COUNTY OF SAN MATEO
PLANNING AND BUILDING DEPARTMENT

DATE: May 27, 2009

TO: Planning Commission

County File Number: PLN 2005-00603 (Ehteshami)

Section A.A Elevation Study

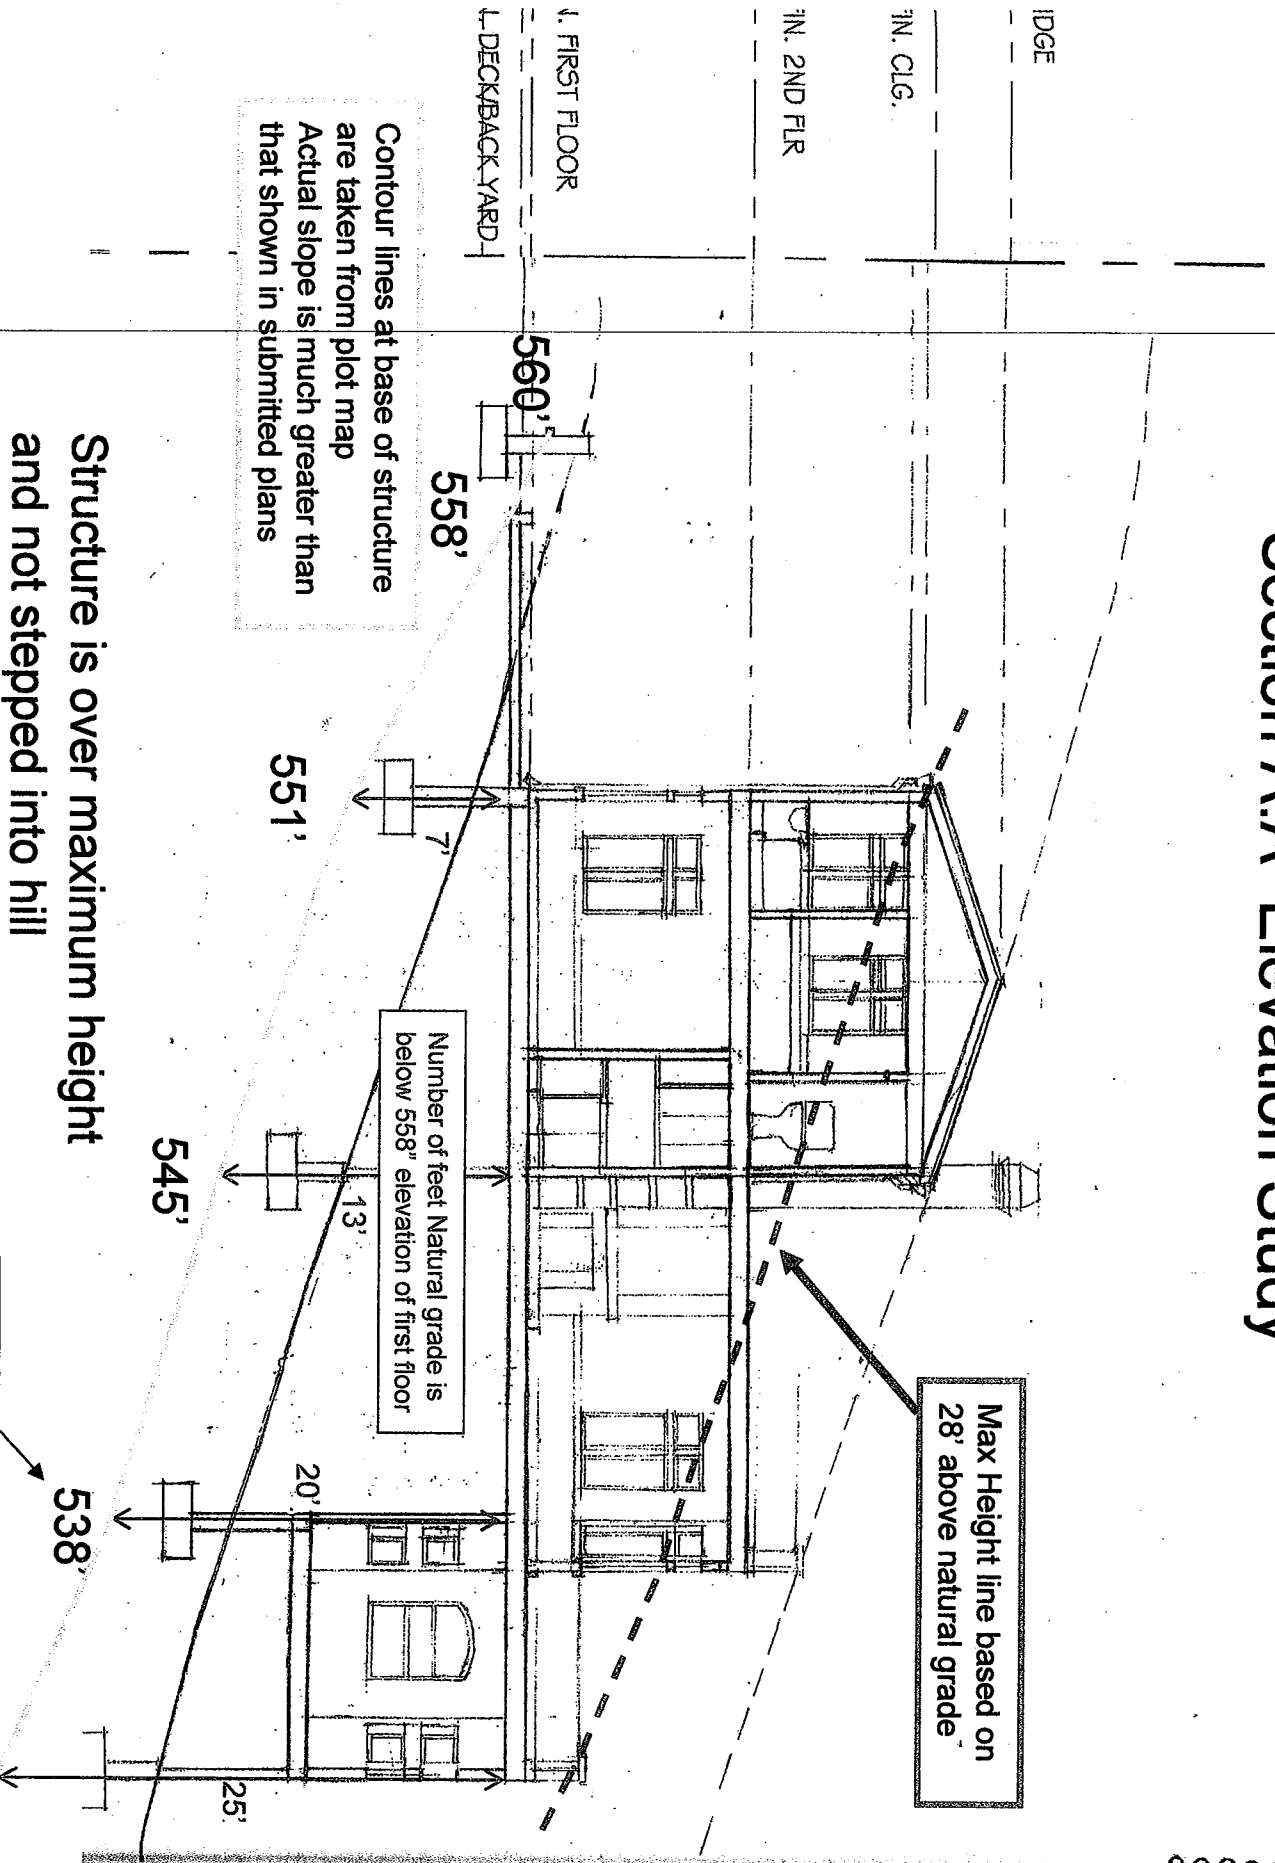
Contour lines at base of structure are taken from plot map
 Actual slope is much greater than that shown in submitted plans

Exhibit A - Site plan
Showing arc for
Undeveloped Extension of
Estrada Place

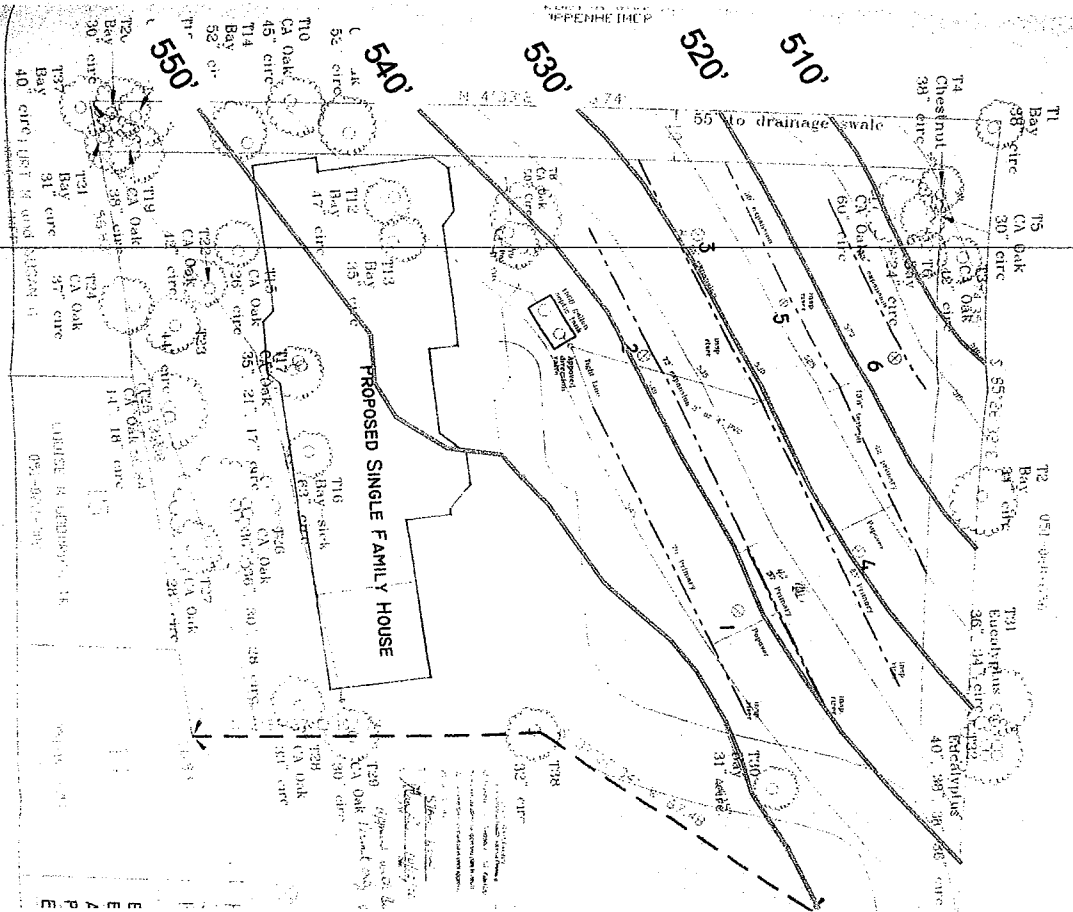
Septic System Plan:
With arc for Undeveloped Extension
of Estrada Place

Proposed leach field on County land

Two different Topo maps submitted

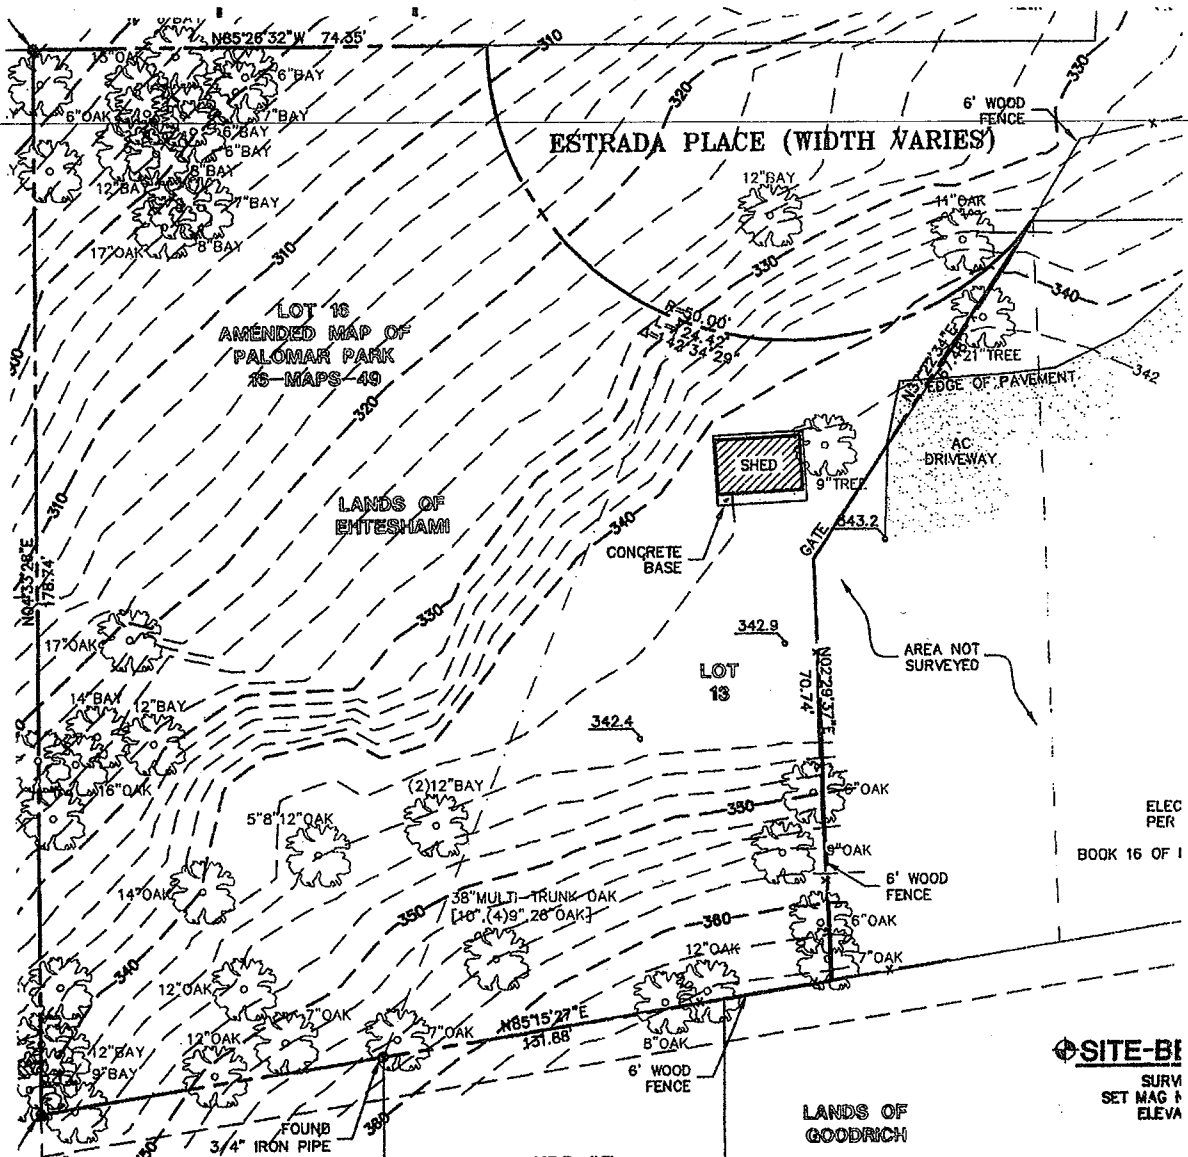
Below is the topological survey done in **April of this year**, notice the difference between this current survey and the old one above.

- A new geotechnical report needs to be generated using the correct topological data and comprehending the more recent slide activity to ensure that the recommendations for stabilizing the slope are still valid.
- The grading requirements to stabilize the slide area need to be included in the estimates for the site as they will be considerable with the removal of 5 to 9 feet of material to install the keyways and leach field.

Exhibit 1:

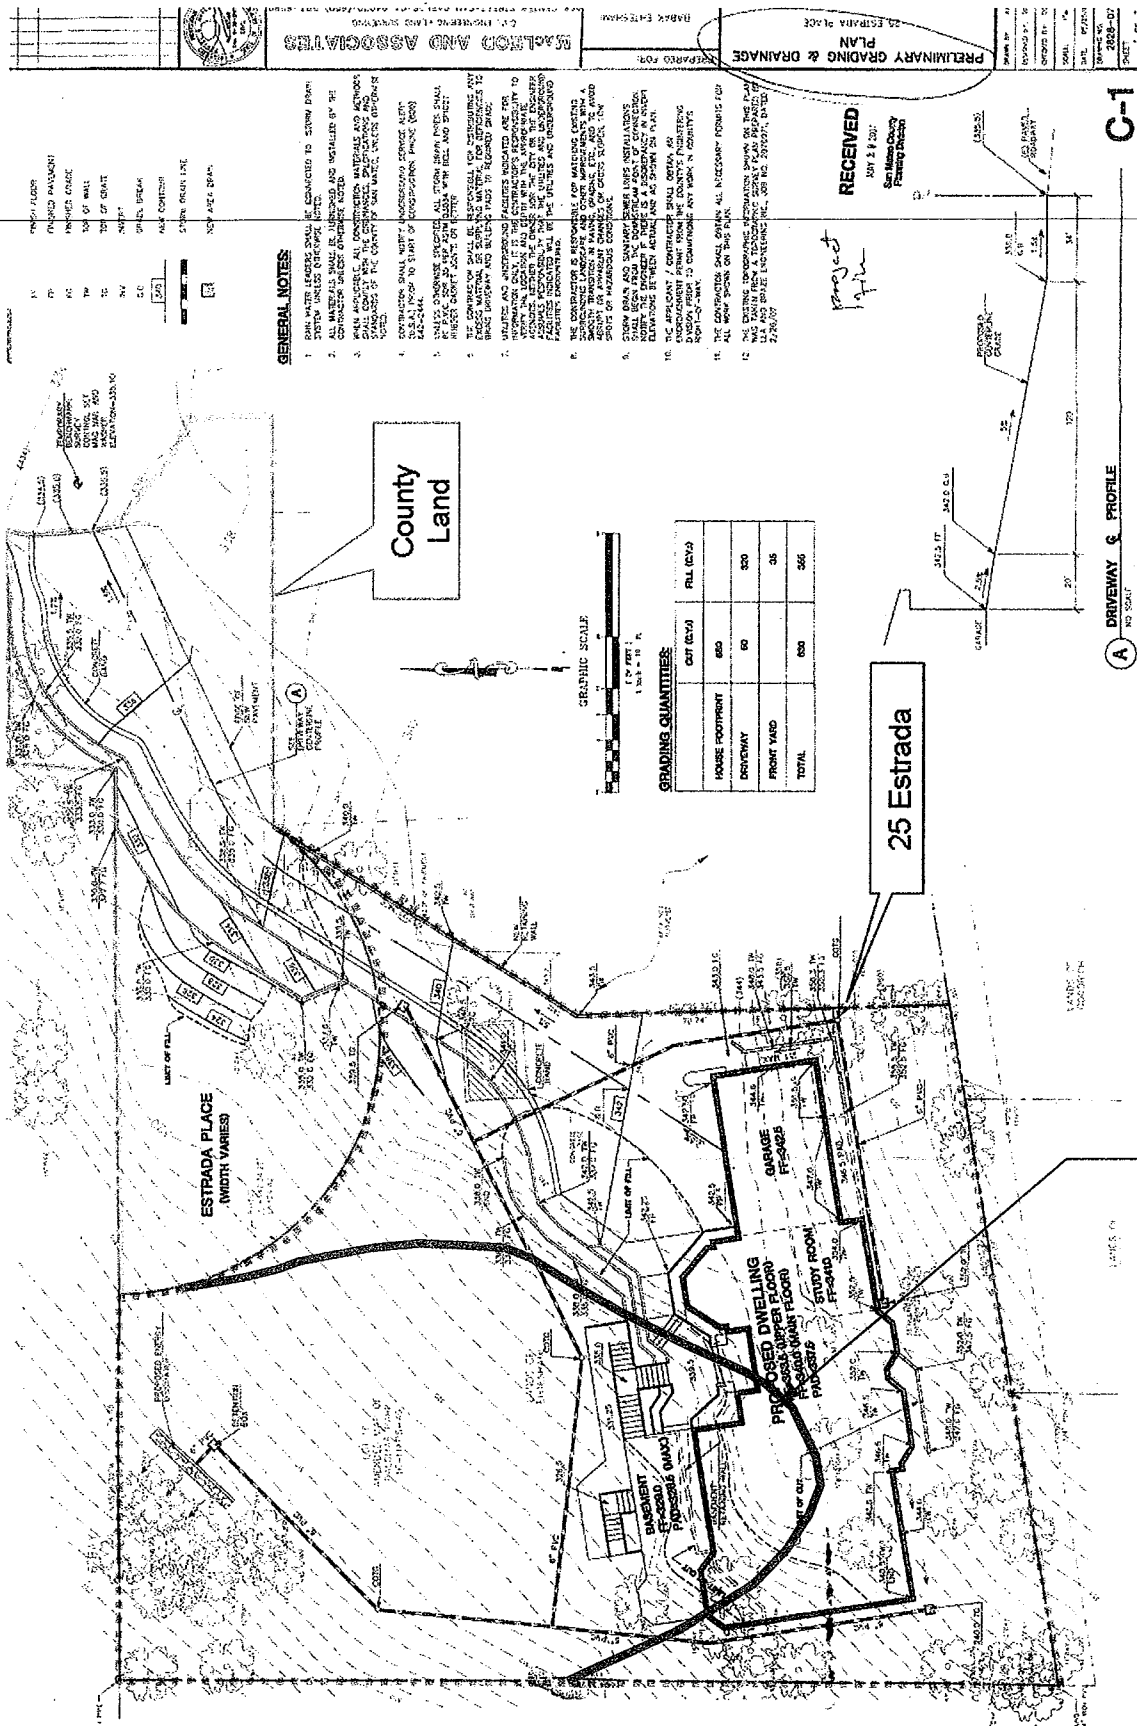
- The locations of these slides start in an arc that goes through the Northwest front corner of the proposed house and continues along the proposed driveway and covers ~50% of the lot. (see red line in Exhibit 1—page 6)

Approximate location of Head Scarp --- overlay map from 2001 geotech map on to May '07 grading plan

Drawing 1:
Study of proposed drainage plan for 25 Estrada.
Focusing on water that will flow into catch basin system near the property line with 632 Palomar.

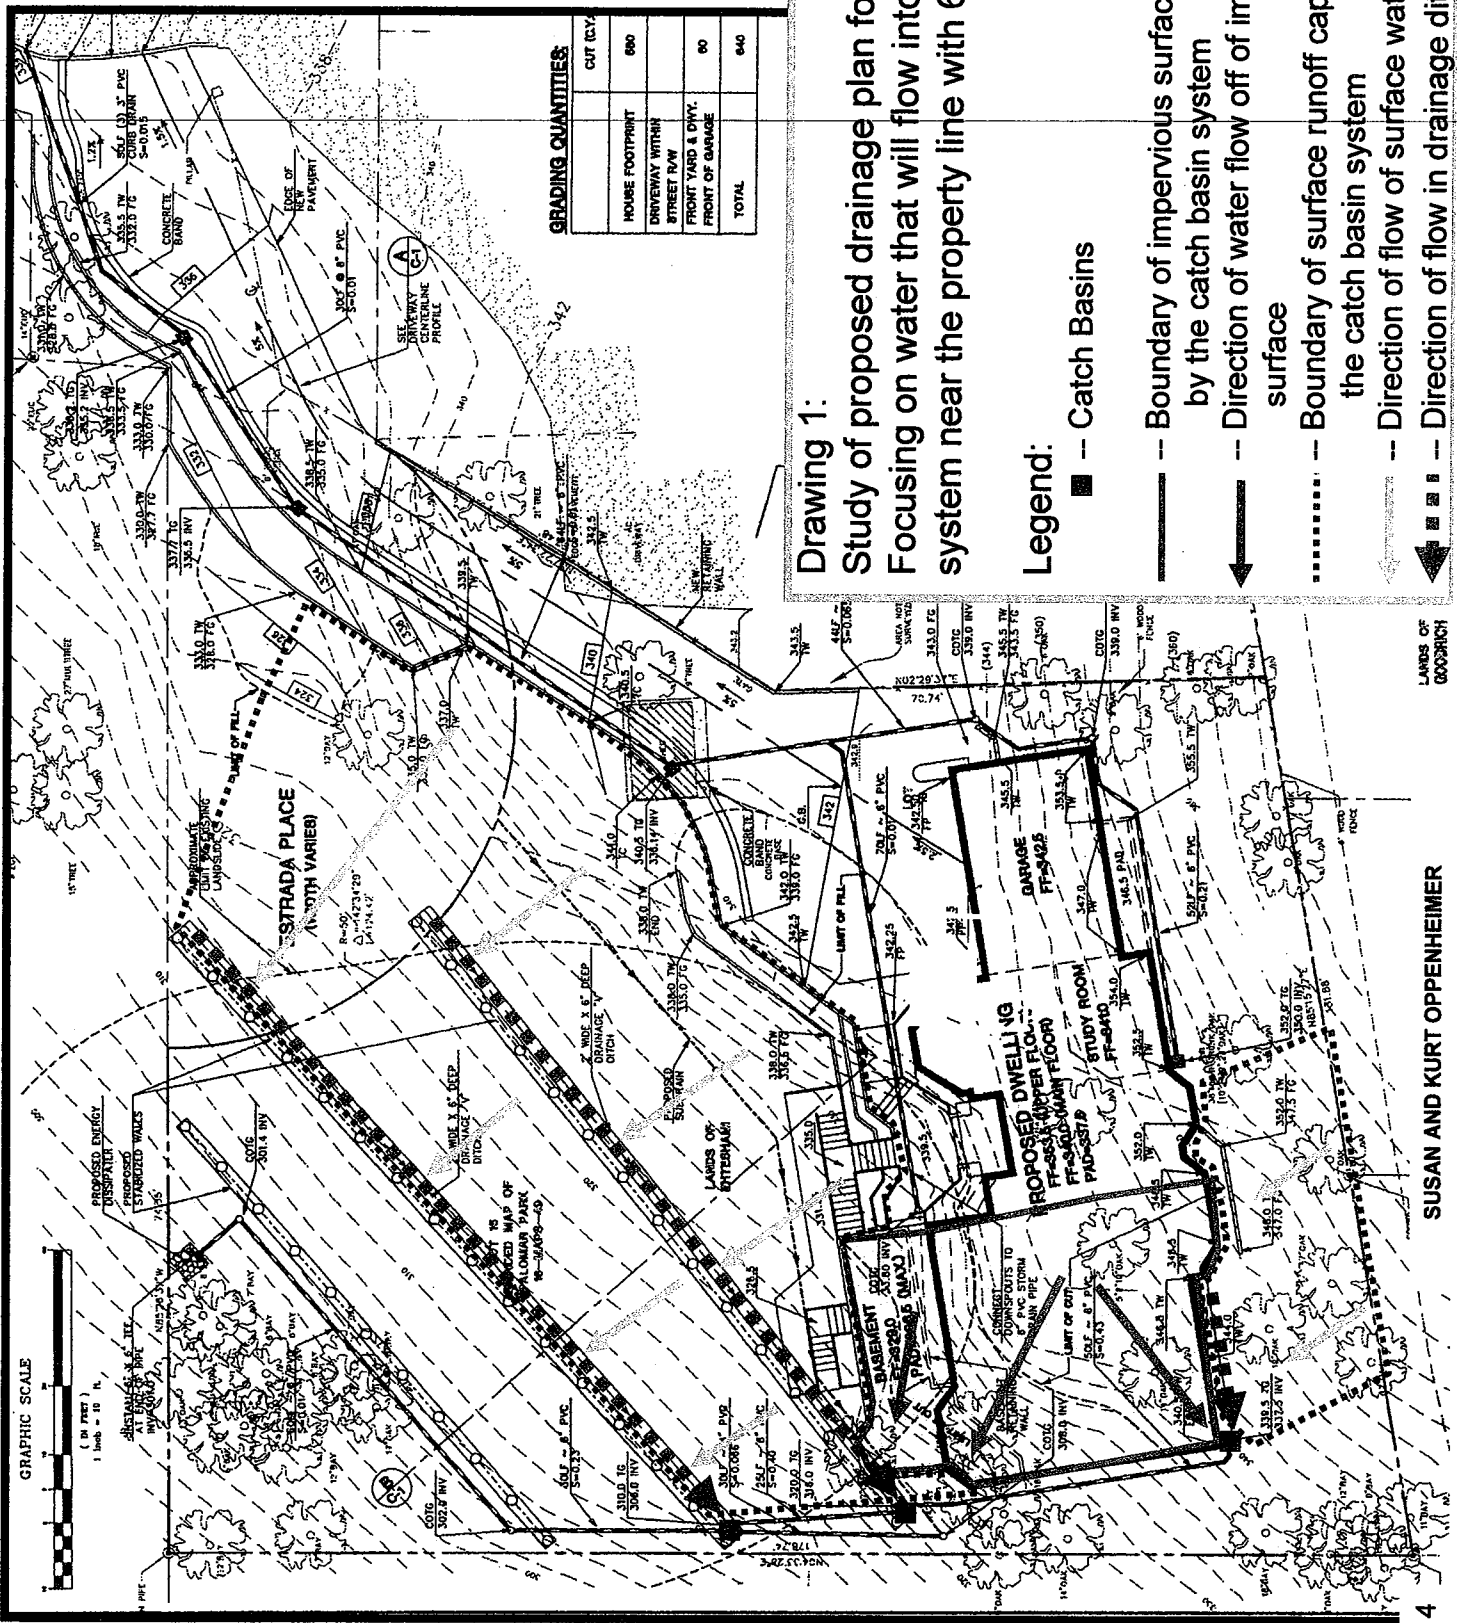
- a) We are still concerned with the revised drainage plans for the site regarding water directed toward the western property line. Each of the three catch basins has a 2' wide x 6" deep drainage ditch collecting surface run off and run off from impervious surfaces on the western half of the structure. See attached Drawing 1. Any significant amount of rain will cause the drainage ditches to direct both water and debris to the catch basins. In the best case the debris will flow through the grate of the basin, in the worst case the debris will clog the grate or plug the 6 inch drainage line. This is based on our experience of living in the Palomar hills for 20 years and maintaining the 8 inch drainage system on our own property which clogs regularly with twigs and leaves.

Two of the three catch basins are within a few feet of the property line, with our property being downhill of them. With 25 Estrada's drainage plan, any failure will cause the water to flow directly across our property to the creek at the bottom of our property. See drawing 2 - composite of Drawing C-1 for 25 Estrada and the original site plan for our lot. The pink arrows in drawing 2 show the down hill path the water will take when failure occurs.

The construction of the lower two stitch pier walls appears to come to within one or two feet of the property line. Is this allowed within the 10' setback? If so, the approval of such a plan by the county does not imply the applicant has any right to access our property with construction equipment, personnel, material or debris in order to execute the construction.
